RE: Depleted Uranium Performance Assessment (DUPA) for the Clive Facility
Round 1 Interrogatories
DRC Radioactive Materials License 2300249

**UTAH DIVISION OF RADIATION CONTROL:
ENERGYSOLUTIONS CLIVE LLRW DISPOSAL FACILITY:
UTAH LLRW DISPOSAL LICENSE –
CONDITION 35 (RML UT 2300249)
COMPLIANCE REPORT
(JUNE 1, 2011)
INCLUDING FINAL REPORT, VERSION 1.0
(APPENDIX A)
AND
APPENDICES 1–17 TO APPENDIX A
AND
COMPLIANCE REPORT, REVISION 1
(NOVEMBER 8, 2013)**

ROUND 1 INTERROGATORIES

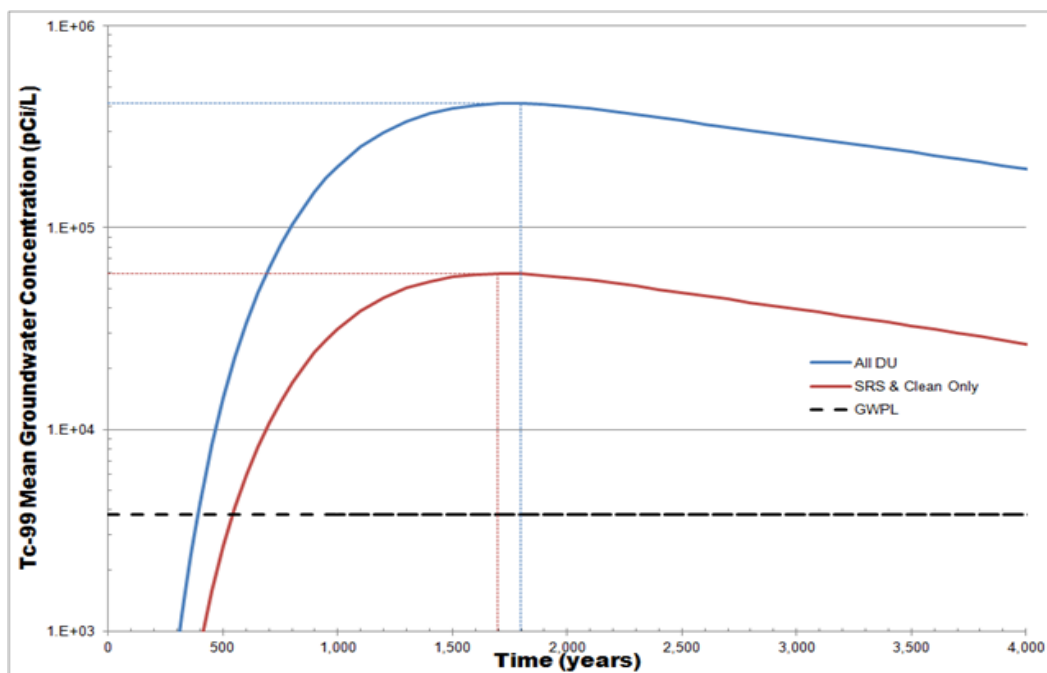
It is not clear that all of the groundwater protection criteria will be satisfied if the stated Tc-99 limits are imposed on the waste. According to Table 5 of the Waste Inventory report, the PA assumes that the mean Tc-99 content is 23,800 pCi/g. This model input waste source term concentration appears to need additional justification and possible revision, as noted in other interrogatories. Section 2.5, page 2-12, of the 2013 Compliance Report, Revision 1, indicates that the DU waste is to be buried at 10 meters. In this case, FRV1 Table 2 shows a peak mean for Tc-99 of 14,400 pCi/L, which is significantly above the GWPL of 3,790 pCi/L.

The figure below shows SC&A's GoldSim simulations comparing Tc-99 concentrations against the GWPL. One case indicates that the Tc-99 GWPL is exceeded after 390 years. We also ran a

case where the only source of Tc-99 was the DUO_3 from SRS and determined that the Tc-99 GWPL would be exceeded after 539 years. In another simulation, we decreased the infiltration rate to 0.09 cm/yr (Whetstone 2012, Section 2.4.1) and determined that the Tc-99 GWPL was exceeded in 494 years. Note that none of SC&A's simulations demonstrated that shallow Clive groundwater quality would be protected, below the Tc-99 GWPL, for at least 10,000 years. Based on FRV1 Table 2 and our simulations, it appears that Tc-99 will not meet the established GWPL if the DU is buried at 10 meters.

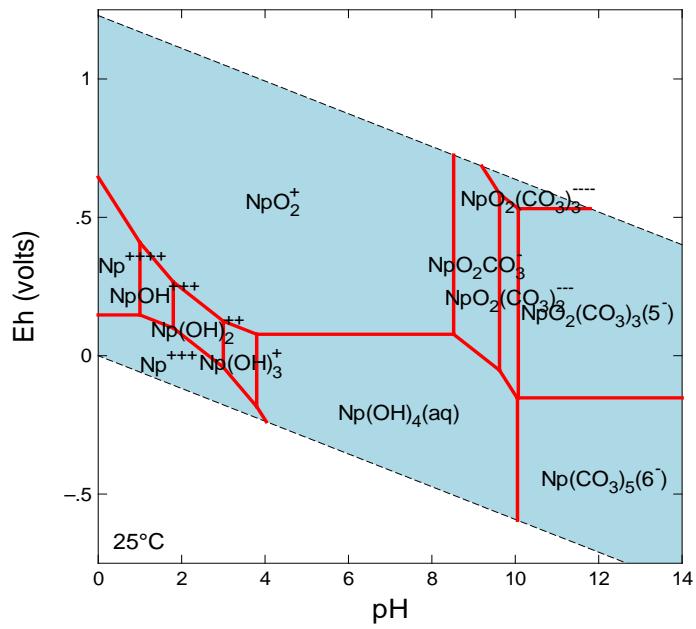
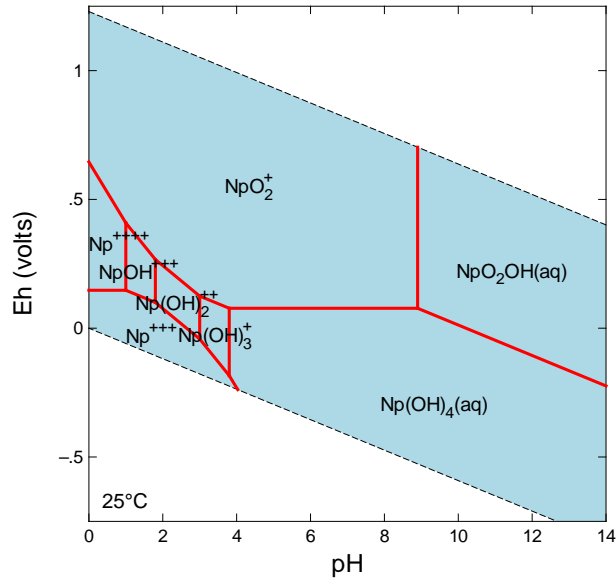
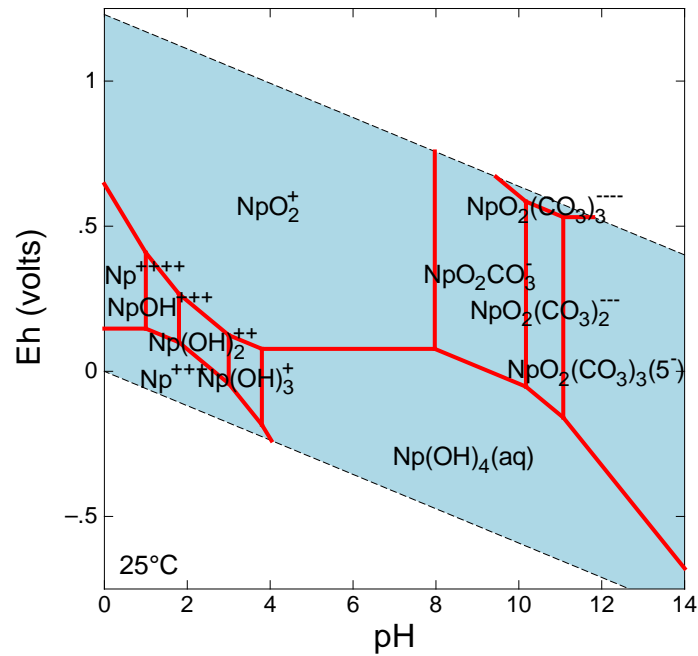
Section 4.1.6, page 13, of the Geochemical Modeling report states that “*The transient, mildly reducing conditions that can exist at Clive and the presence of carbonates may lead to the formation of Np(VI) carbonate complexes above pH 7.*” However, based on the E_H -pH diagrams below, Np(VI) phases will not form under the reported conditions of the Clive site. Modeling was performed without atmospheric $CO_2(g)$ (top figure), with atmospheric $CO_2(g)$ (middle figure), and with 350 mg/L of total carbonate (bottom figure) with Geochemist Workbench Standard 8.0 using database thermo.com.v8.r6+.dat. The maximum carbonate concentration listed in Table 5 of the Geochemical Modeling report is 350 mg/K. Only a small region of stability for Np(VI) exists in the presence of carbonate around pH 10 and electrode potentials of 0.6 volts. Increasing the carbonate concentration only increases the stability of the Np(V) complexes, not the NP(VI) complexes. If the mention of Np(VI) in the text was a typographical error and the text intended to refer to Np(IV) forming carbonate species, it should include a reference for the thermochemical constants used to determine that speciation.

If for any reason EnergySolutions is unable to reconcile these or any other discrepancies with neptunium K_d values used in the GoldSim model with local Clive geologic and geochemical conditions (vadose or shallow aquifer), EnergySolutions will need to (1) use conservatively low K_d values found in available peer-reviewed technical literature or (2) collect Clive soil and groundwater samples and perform independent laboratory testing to determine a site-specific empirical value(s).

(Modeling was performed with Geochemist Workbench Standard 8.0 using database thermo.com.v8.r6+.dat.)

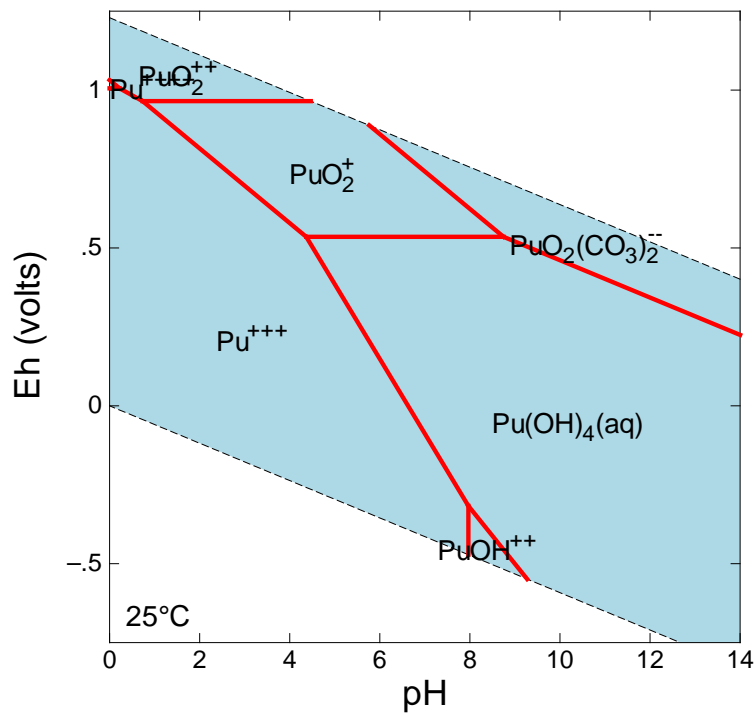
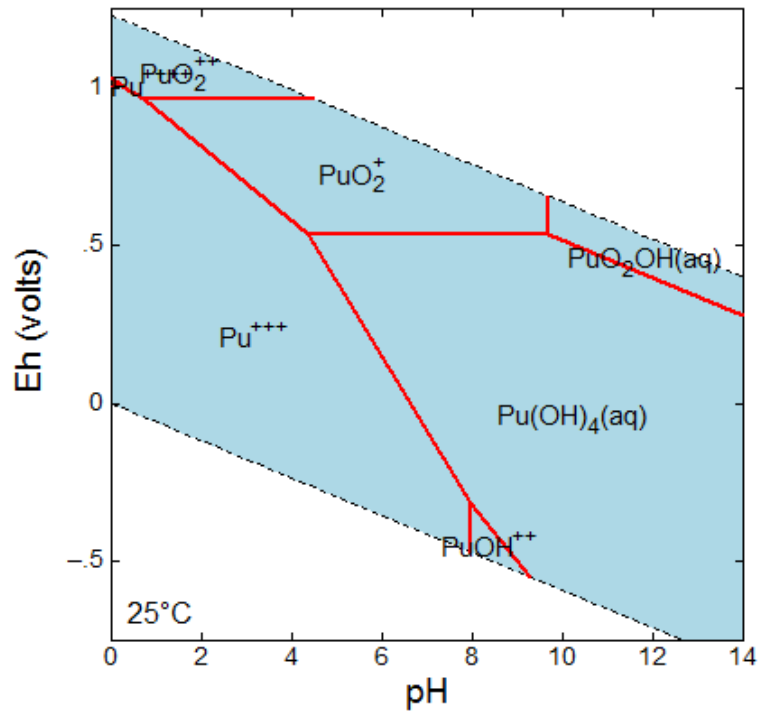
The specific data or model used to verify the statement should be provided. The simple Eh-pH figure below, generated from our own modeling, and many similar ones that can be found in the literature indicate that Pu(V) and Pu(VI) species will likely not be the dominant species given the pH and Eh ranges reported in Table 5. The top figure is the model output in the absence of atmospheric carbonate and the bottom figure is the model output with the carbonate concentration set to 350 mg/L total carbonate (which is the maximum carbonate concentration listed in Table 5 of the Geochemical Modeling report). There is no significant change in the redox speciation between the two models. Since the existing thermochemical databases for plutonium may have some conflicting data, it is important to document the model used for the statements quoted from the Geochemical Modeling report. However, even if Pu(V) and Pu(VI) are thermochemically predicted to be stable under the porewater conditions at the Clive site, many studies have demonstrated surface mediated reduction of Pu(V) on metal oxide, soil, and sediments (see Kenney-Kennicutt and Norse, 1985; Powell et al., 2004 and 2005; Romachuk et al., 2011; and Sanchez et al., 1985).

Fig. 1. Profile of cover used at Monticello Disposal Facility. The cover prolife above the geomembrane constitutes the water balance cover

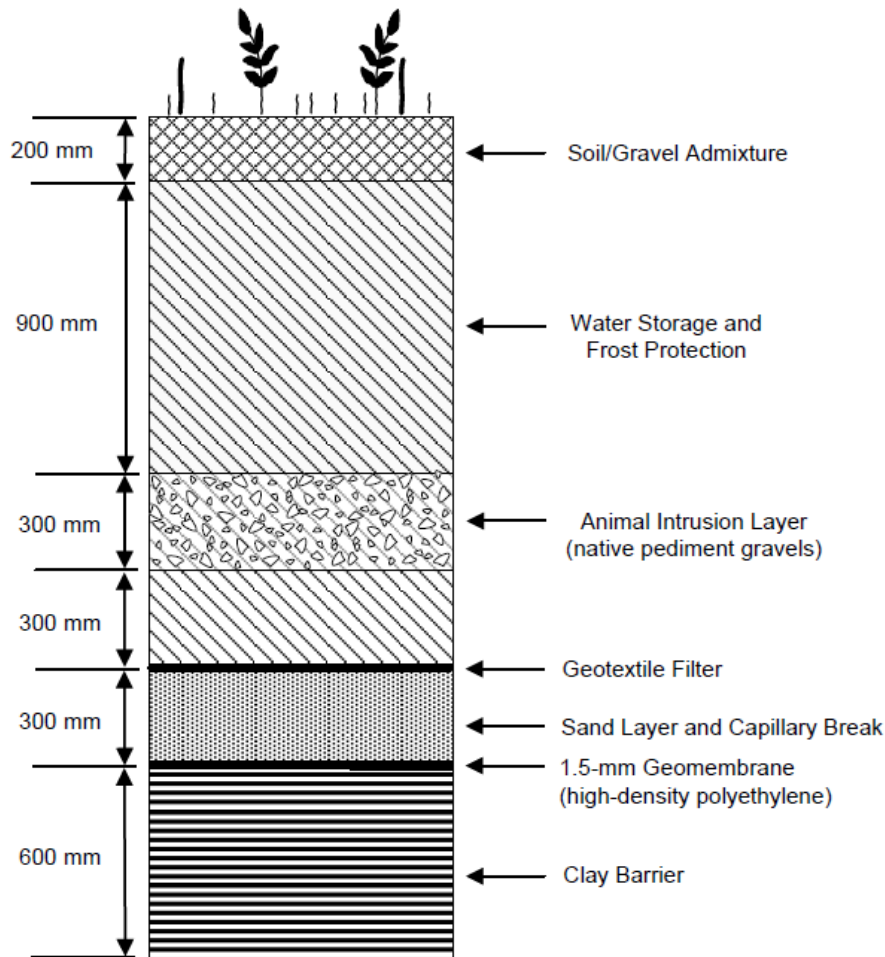
Figure 1 (Benson et al. 2008) and Figure 2 (Bareither and Benson 2013) show the cover profiles at these sites. Both sites employ large-scale volumetric lysimeters based on the design developed in the Alternative Cover Assessment Program, as described in Benson et al. (2001) and Albright et al. (2010). The Cheney site has two replicate lysimeters, labeled C and R. Percolation rates measured at these sites are summarized in Table 1 (Monticello) and Table 2 (Cheney) (DOE 2012, DOE 2013). The lysimeters at Monticello and Cheney are at 2% grade, similar to the top deck of the Federal Cell.

The average percolation rate for the water balance cover at Monticello is 0.5 mm/yr, which is about 25 times higher than the percolation rate predicted for the water balance cover for the Federal Cell. Monticello is in a wetter climate, which can increase the percolation rate, but Monticello also uses a much thicker storage layer (Figure 1) than the cover proposed for the Federal Cell, which will reduce the percolation rate. Thus, the very low percolation rate predicted for the Federal Cell needs additional justification.

Fig. 2. Profile of rock armor cover used at Cheney Disposal Facility.

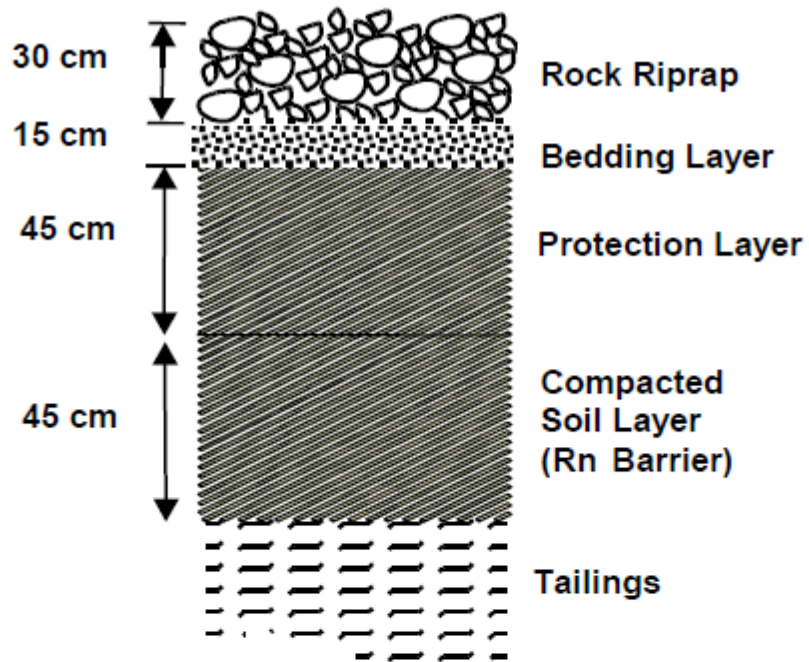
Similarly, for the rock armor cover at the Cheney Disposal Facility, the average percolation rate is 1.0 mm/yr (Cheney-C) or 2.8 mm/yr (Cheney-R), or 1.9 mm/yr on average. This percolation rate is more than two times the average percolation rate predicted for the rock armor cover for

the Federal Cell as reported in EnergySolutions (2012) (pp. 3-7 and 3-8), even though the average precipitation at Cheney has been lower than the average precipitation cited for the Federal Cell. The significance of this difference in percolation rates needs clarification.
